MONITORING YEAR 3 ANNUAL REPORT

CROOKED CREEK #2 RESTORATION PROJECT

RE: Crooked Creek II Mitigation Site -Year 3 Monitoring Report
Final Submittal for DMS
DMS ID 94687
DEQ Contract Number D09126S
Yadkin Pee-Dee River Basin – CU# 03040105; Union County, NC

Wildlands Engineering, Inc. (Wildlands) has reviewed the Division of Mitigation Services (DMS) comments and observations from the Crooked Creek II Mitigation Site Draft Year 3 Monitoring Report. The following are Wildlands responses to your comments and observations from the report noted in italics lettering.

Figure 3.0 Integrated Current Condition Plan View
 Crooked Creek #2 Restoration Project
 DMS Project No. 94687
 Monitoring Year 3 - 2018
 Union County, NC

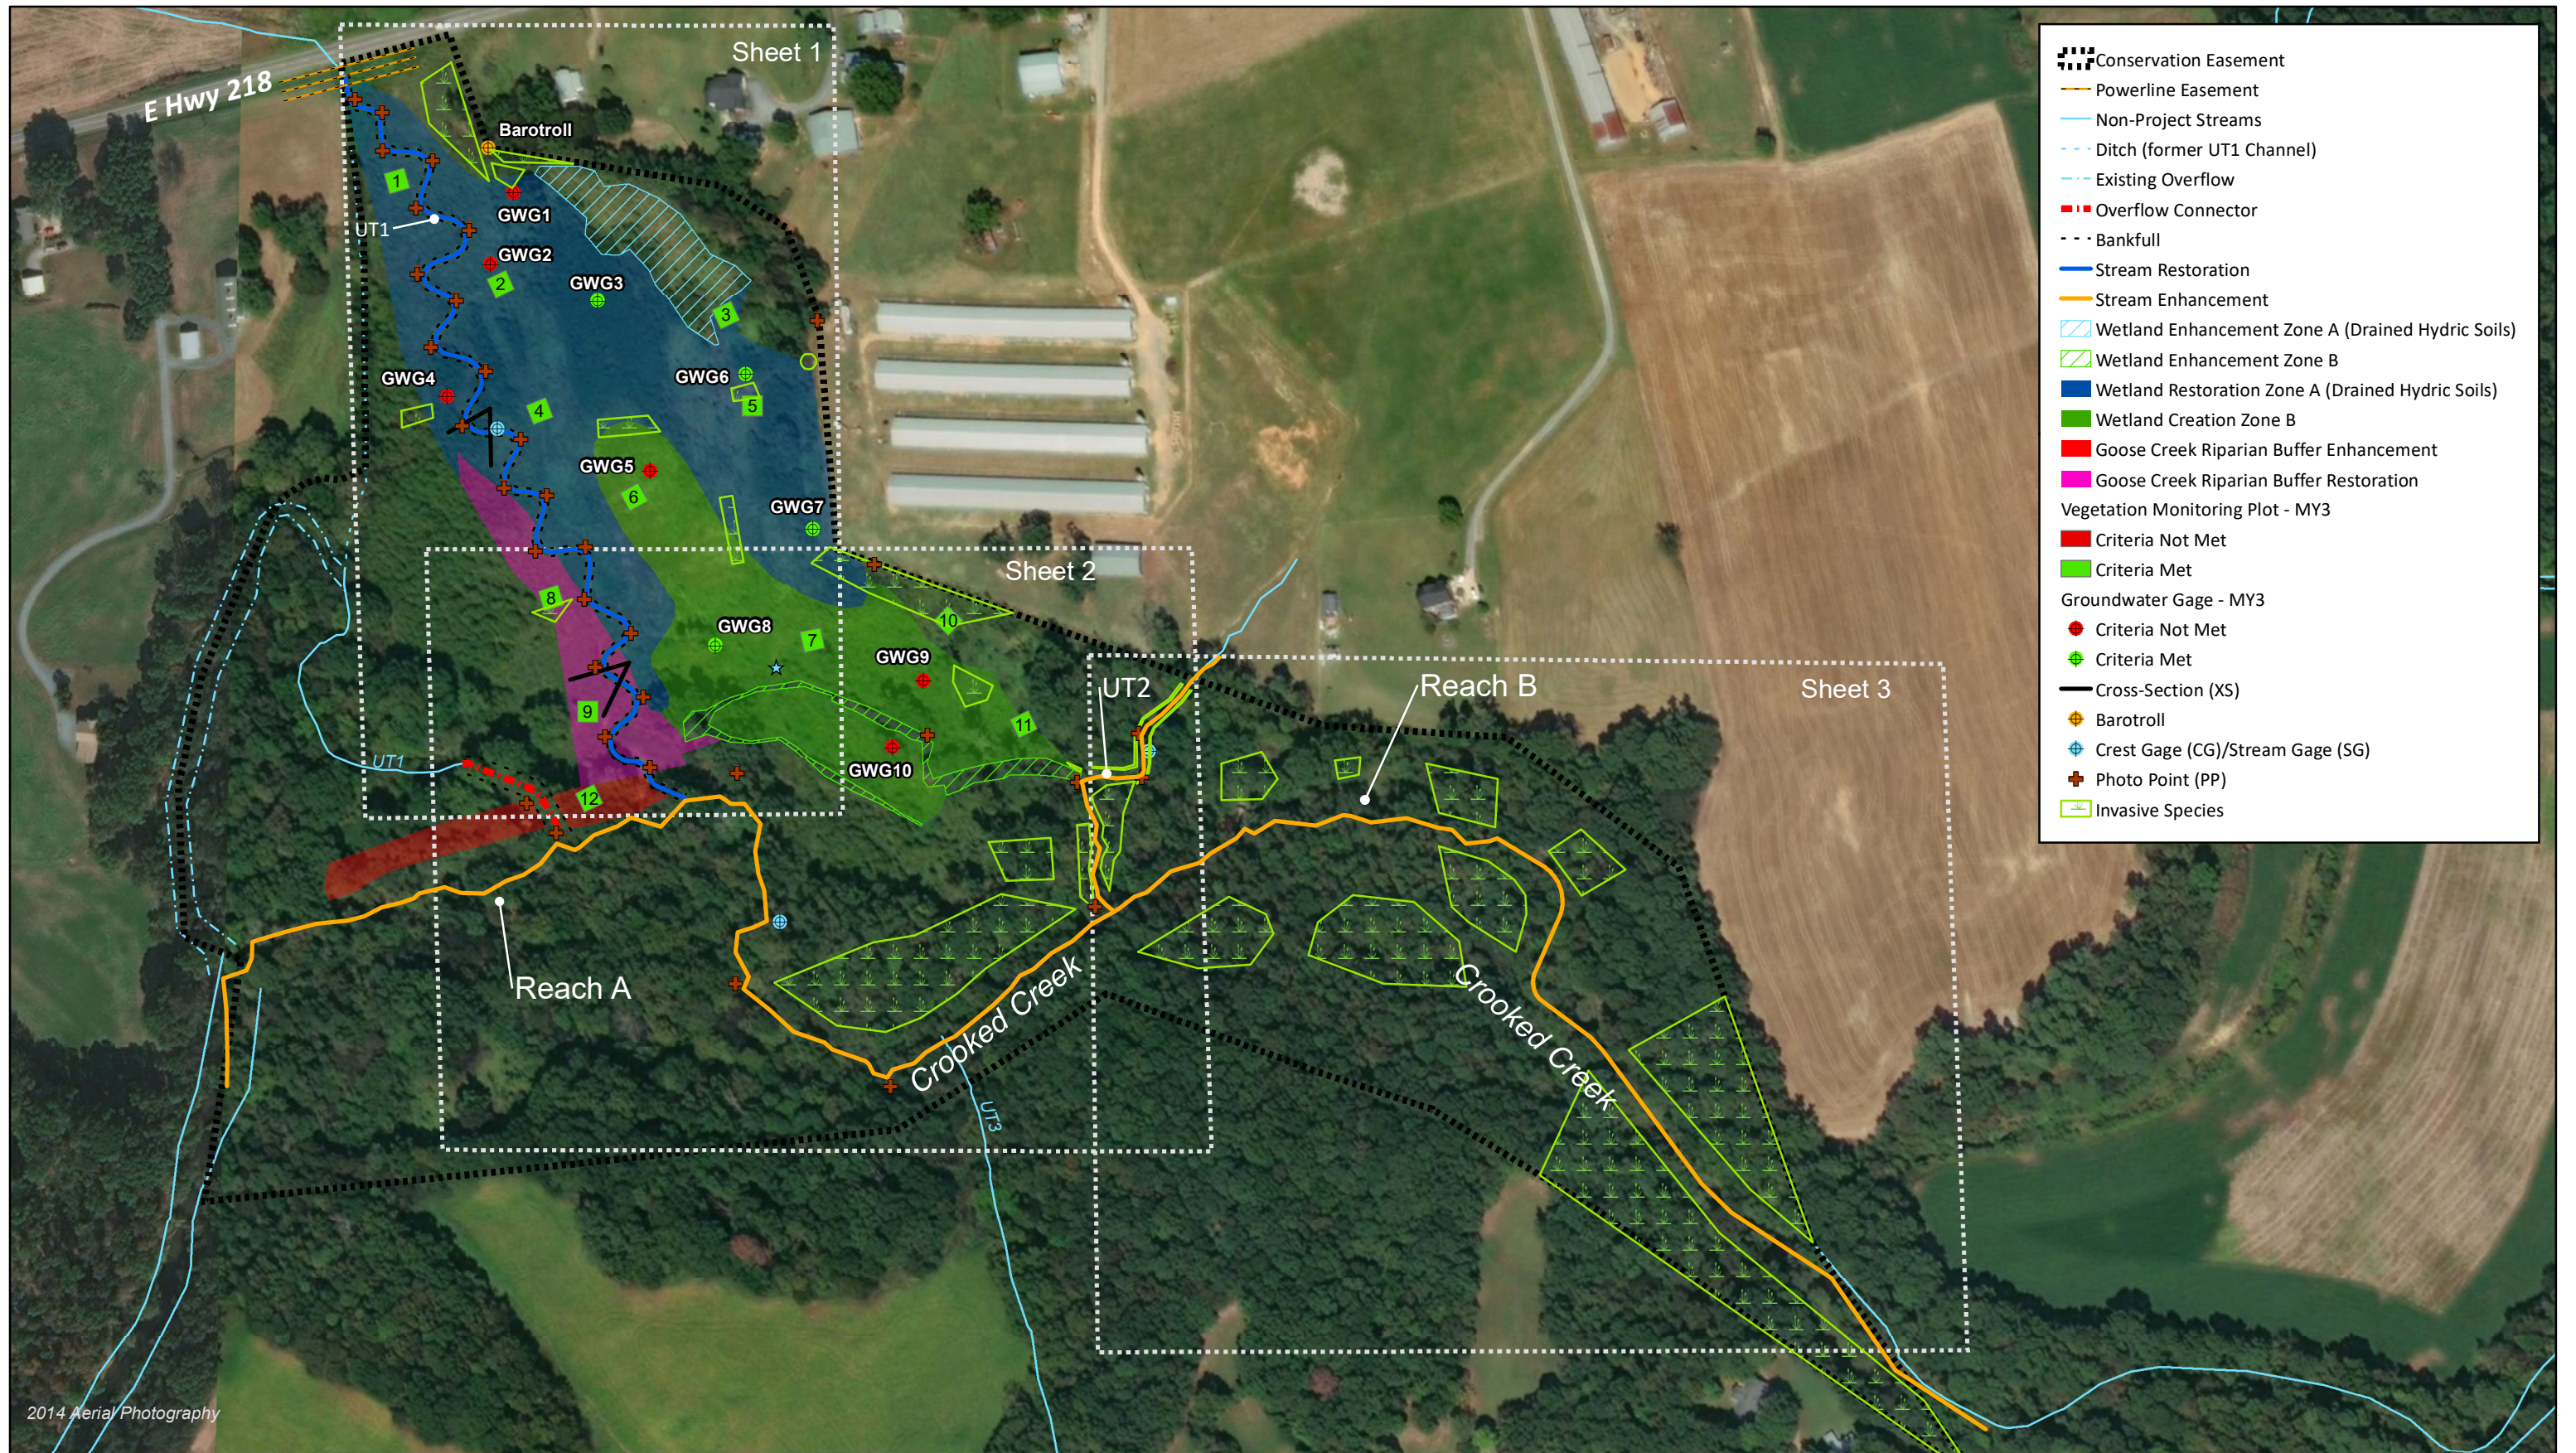
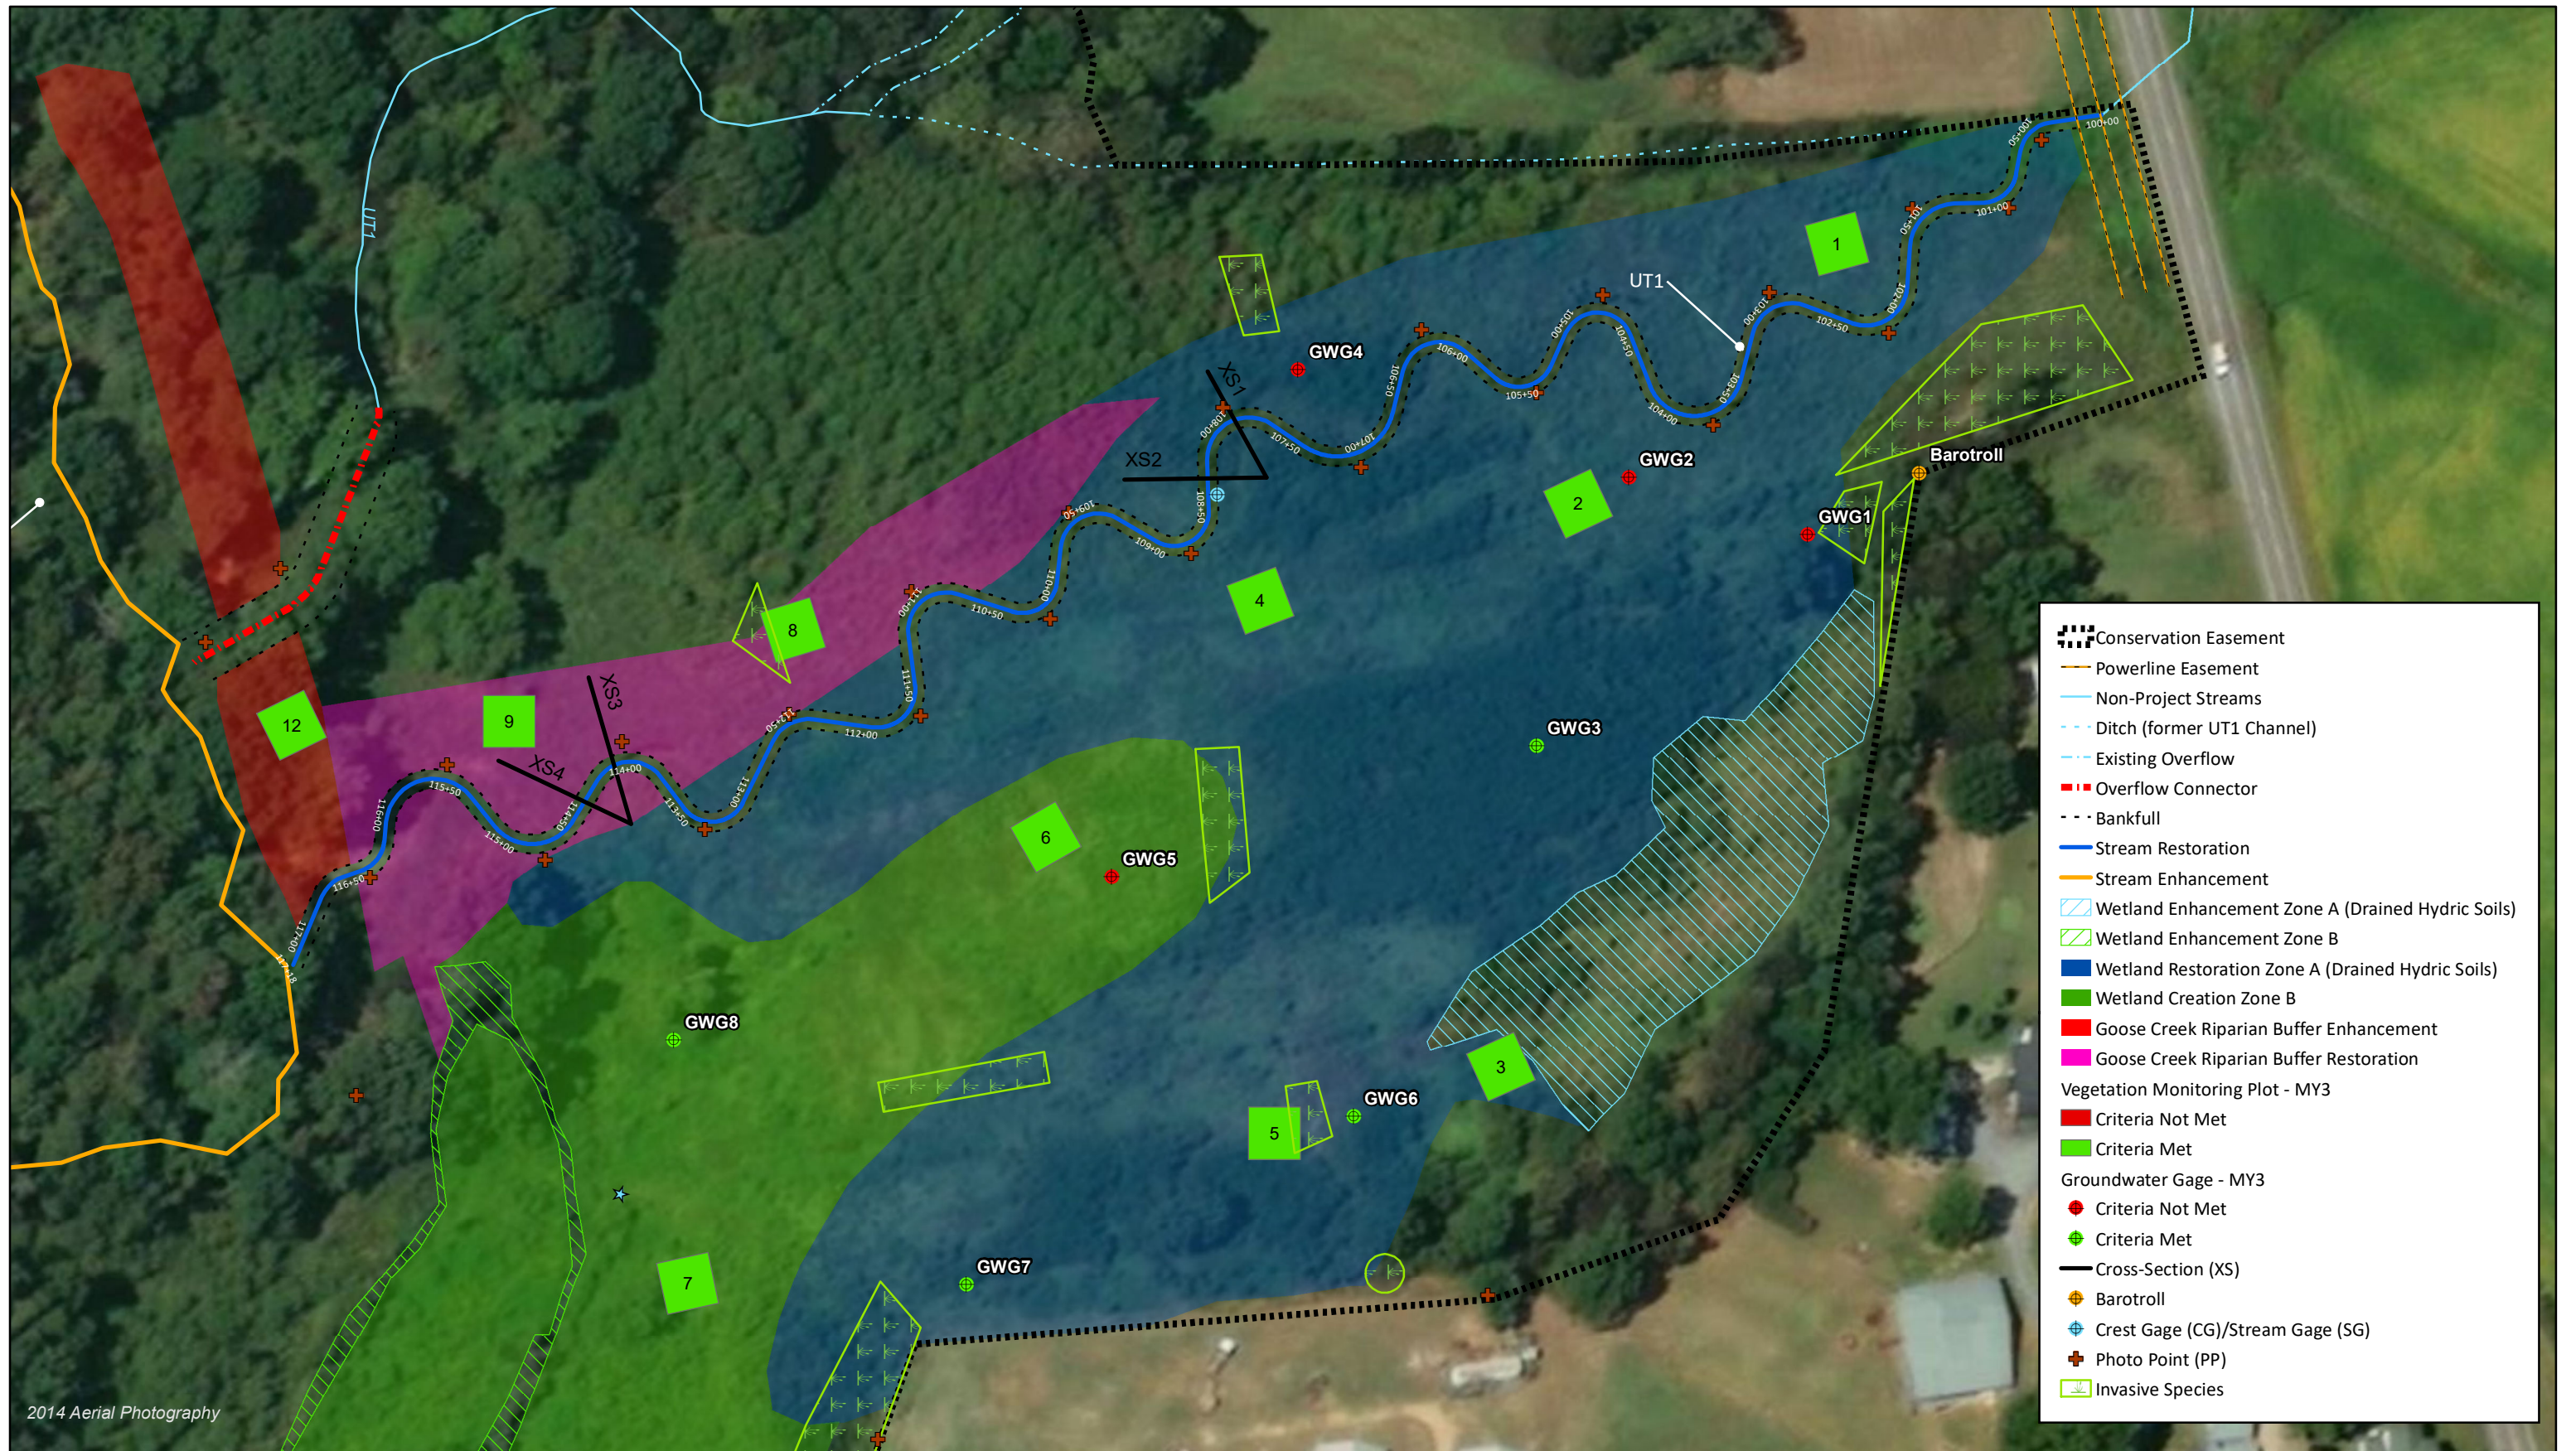
DMS Comment; CCPVs – If possible, please improve the report format/readability as follows: Use a stream centerline for Crooked Creek and UT2; the widened orange colors do not accurately represent the stream width; for example, sections of UT appear to be 50 feet wide.

DMS Comment Add station numbering for Crooked Creek and UT2.

DMS Comment Combine Sheets 1 and 2; and sheets 3,4,5; typically a project this size should not have 6 CCPVs to clearly depict monitoring features.

Wildlands Response; Wildlands updated the CCPV maps by inserting a stream centerline for Crooked Creek and UT2.

Wildlands Response; Wildlands added station numbers for Crooked Creek and UT2.

Wildlands Response; Wildlands combined the CCPV maps as requested.
